AMENDMENT OF SOLICITATION/MODIFICATION OF CONTRACT				1. CONTRACT ID CODE <div style="text-align: center;">J</div>		PAGE OF PAGES <div style="text-align: center;">1 9</div>

Amendment No. 5

AMENDMENT NO. 5 TO SPECIFICATIONS FOR REVITALIZE BARRACKS USMA PREPARATORY
SCHOOL BUILDINGS 1204 & 1205, FORT MONMOUTH, EATONTOWN, NEW JERSEY

SKETCH: STRUCTURAL STEEL
(MECHANICAL ROOM 113 AND SIMILAR)
(REFERENCE DRAWING A-07)

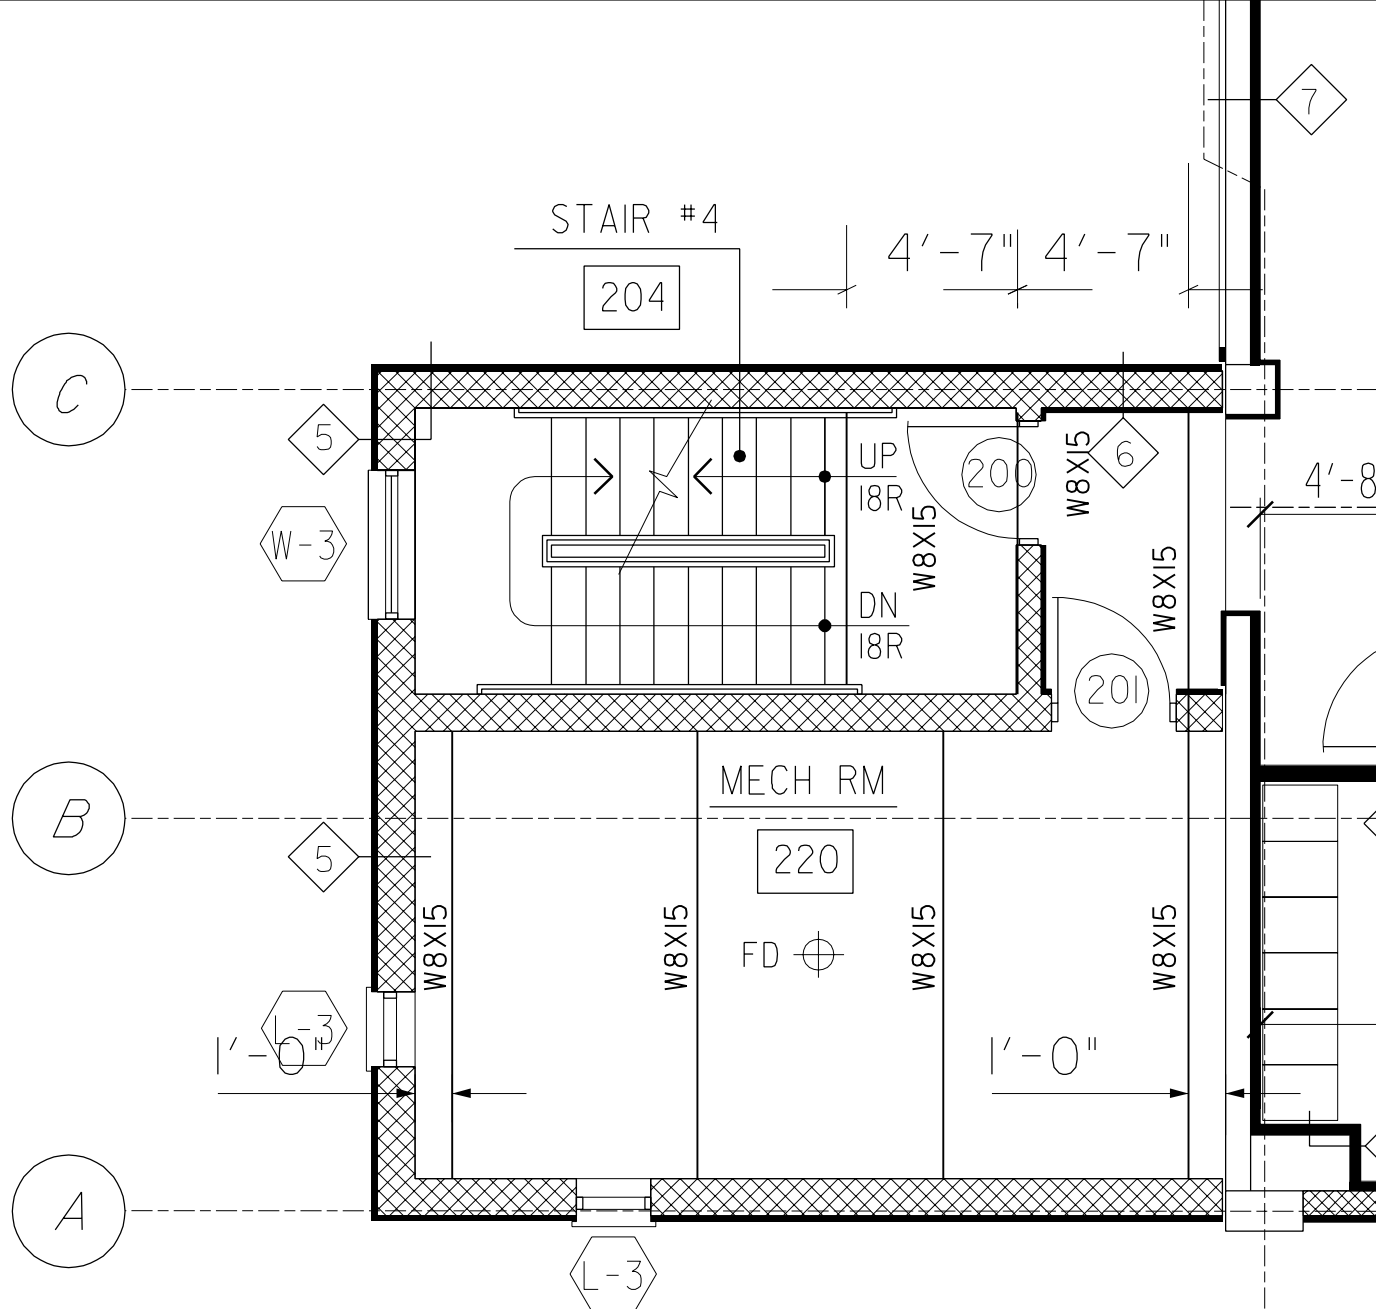
- Handicapped Ramp (Typ.)
 - Structural Steel: (Mechanical Room 113 and similar) (Reference Drawing A-07)
 - Structural Steel: (Mechanical Room 126 and similar) (Reference Drawing A-07)

SKETCH: STRUCTURAL STEEL
 (MECHANICAL ROOM 220 AND SIMILAR)
 (REFERENCE DRAWING A-08)

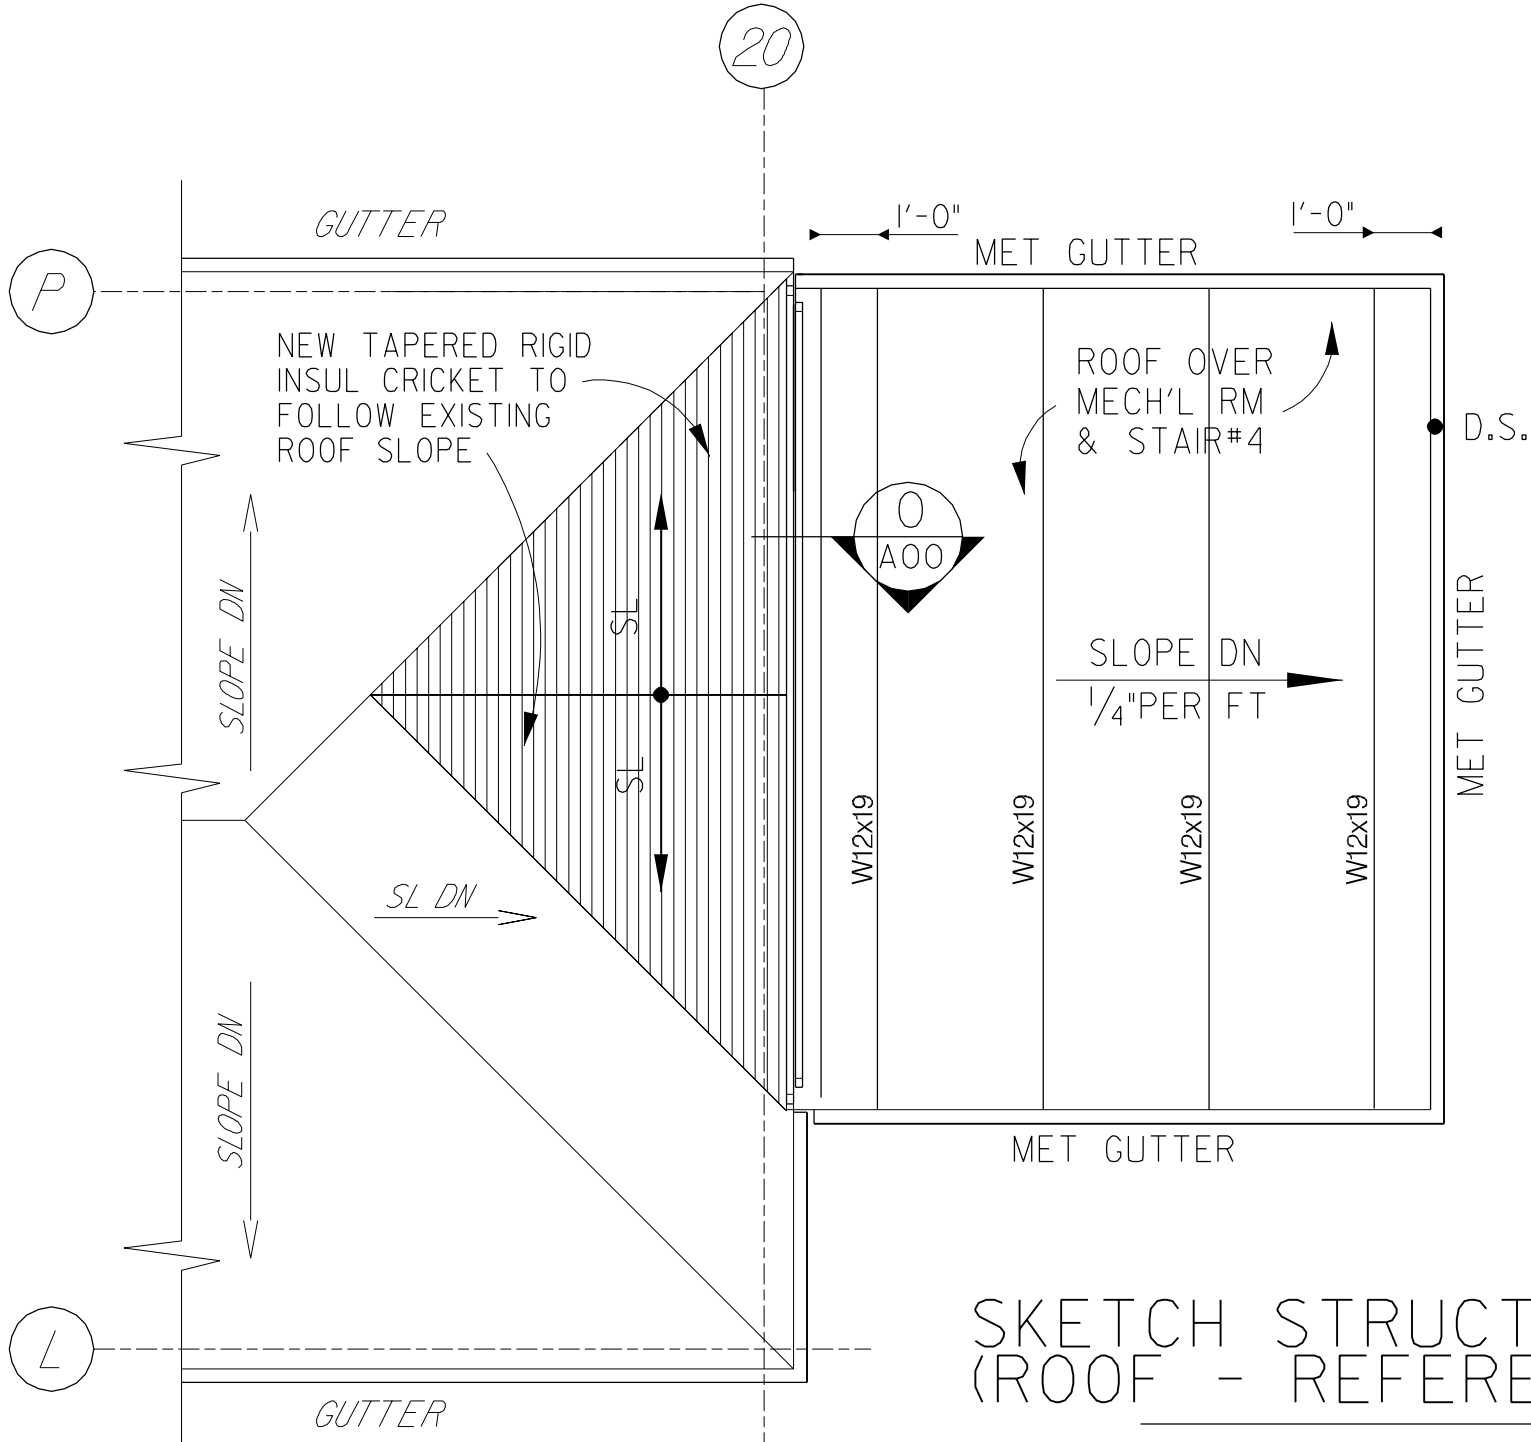
- Structural Steel: (Mechanical Room 212 and similar) (Reference Drawing A-08)
 - Structural Steel: (Mechanical Room 220 and similar) (Reference Drawing A-08)

SKETCH STRUCTURAL STEEL
(ROOF - REFERENCE A-34A)

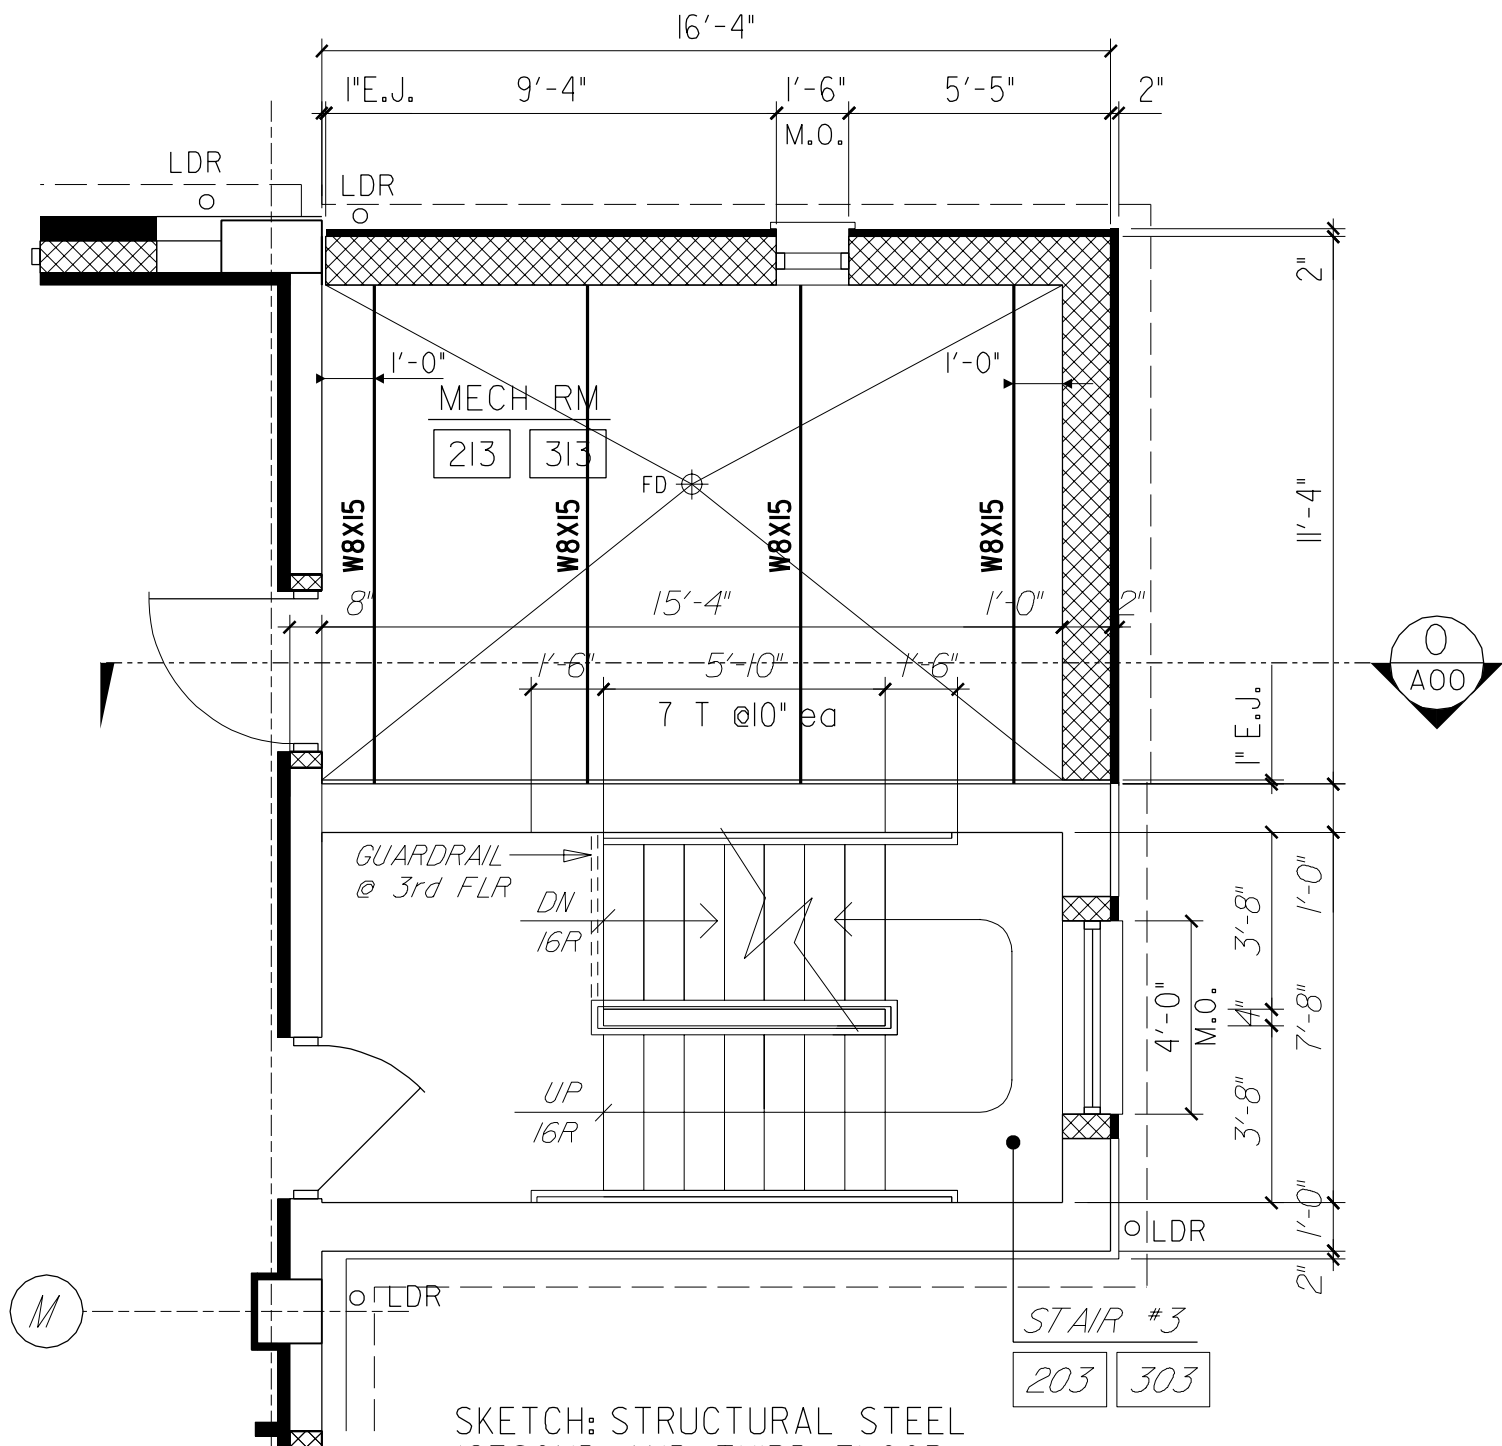
**ALTER GUTTER & FASCIA
AS REQ'D TO MEET NEW
CONDITIONS (V.I.F.)**

NEW TAPERED RIGID INSUL CRICKET
TO FOLLOW EXISTING ROOF SLOPE

MET GUTTER @ BLDG 1205
TO BE ALTERED AS REQ'D
TO MEET NEW CONDITIONS
